**Perry Nuclear Power Plant
Docket Nos. 50-440; 50-441
SER Confirmatory Item - No. 34
Undervoltage Protection**

The following information is provided to amend our June 8, 1982, letter regarding SER Confirmatory Item No. 34 on undervoltage protection. (Ref. FSAR question 430.77).

UNDERVOLTAGE RELAY

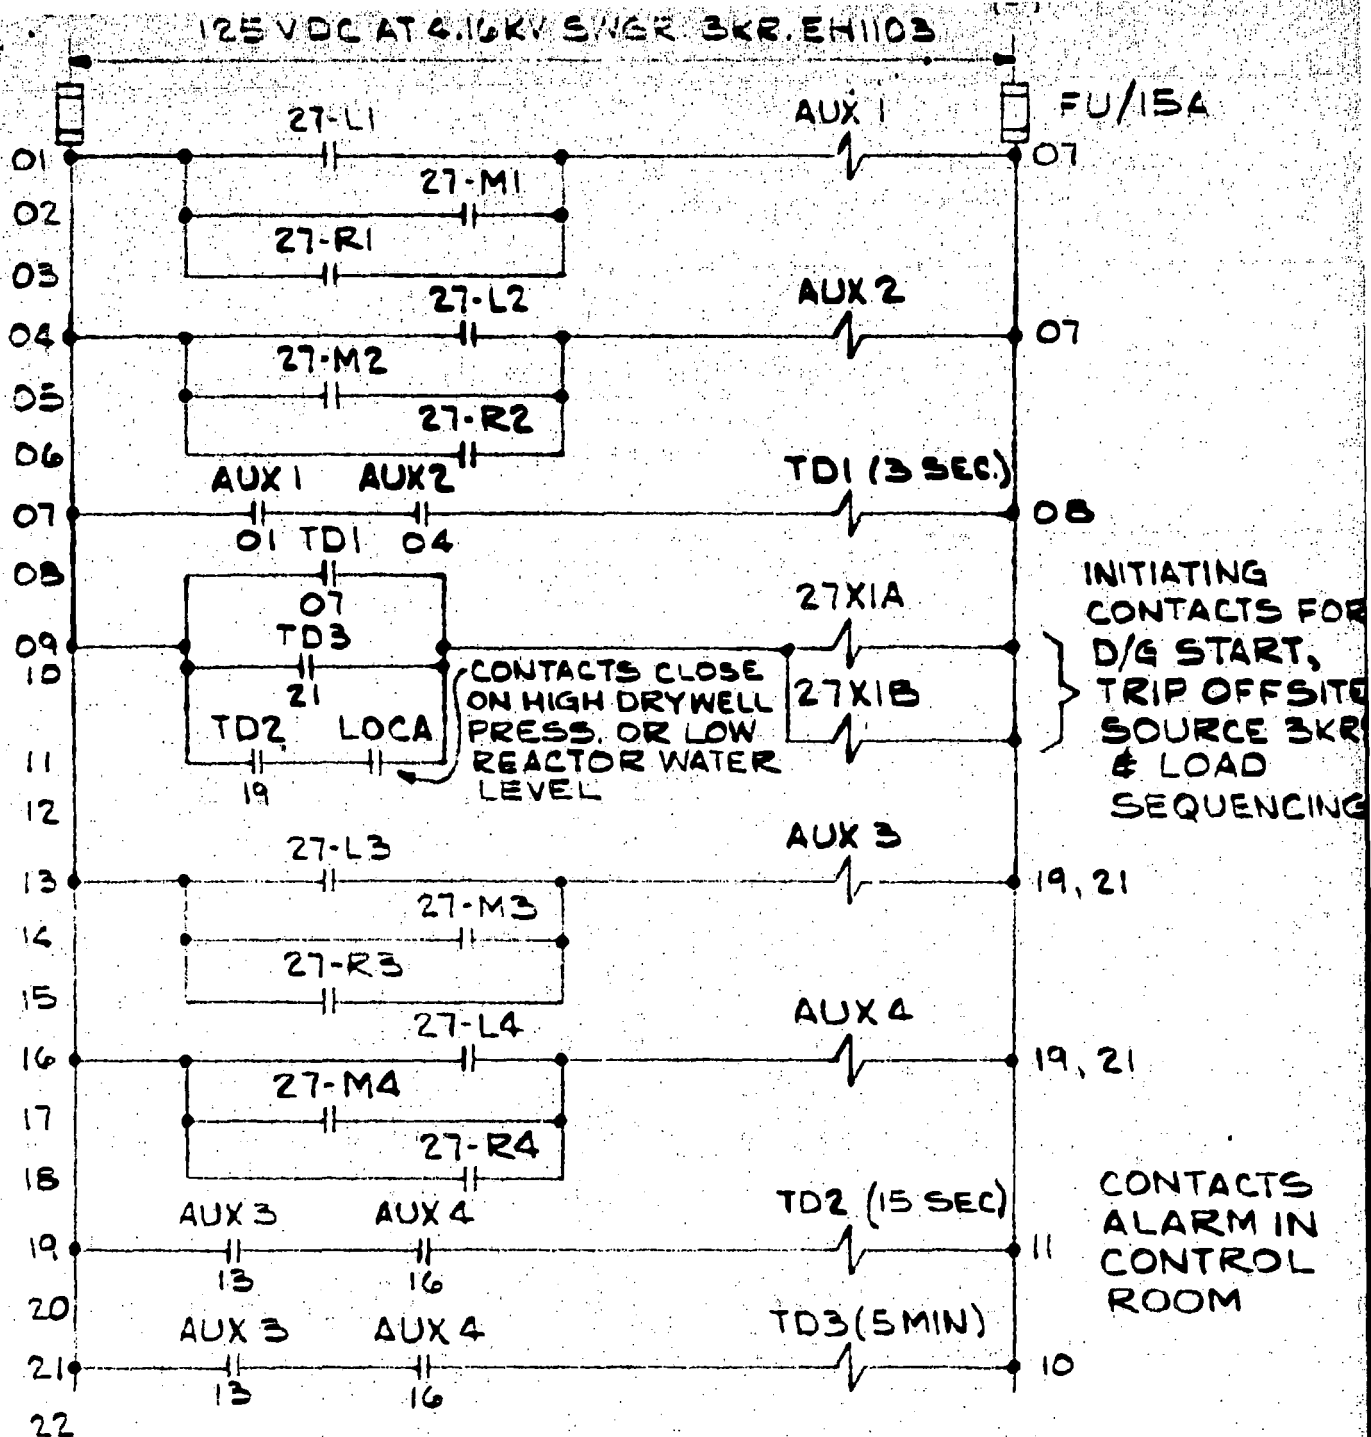
To avoid tripping the offsite breakers during normal load sequencing, the setpoint for the first level of undervoltage protection has been changed to trip at 75% of motor rated voltage instead of 86%. The three second fixed time delay will still remain in effect.

Additionally, the diesel generator start signal after the 15 second time delay from the second level of undervoltage has been eliminated. In order to prevent unnecessary engine starts, this timer will alarm only, allowing operator initiation if the diesels are needed.

UNDERVOLTAGE RELAYS
SET TO TRIP AT 75% OF
MOTOR RATED VOLTAGE.
CONTACTS CLOSE WHEN BUS
VOLTAGE IS BELOW NORMAL.
CONTACTS SHOWN ON SHEET 2.

UNDERVOLTAGE RELAYS
SET TO TRIP AT 96% OF
MOTOR RATED VOLTAGE.
CONTACTS CLOSE WHEN BUS
VOLTAGE IS BELOW NORMAL.
CONTACTS SHOWN ON SHEET 2.
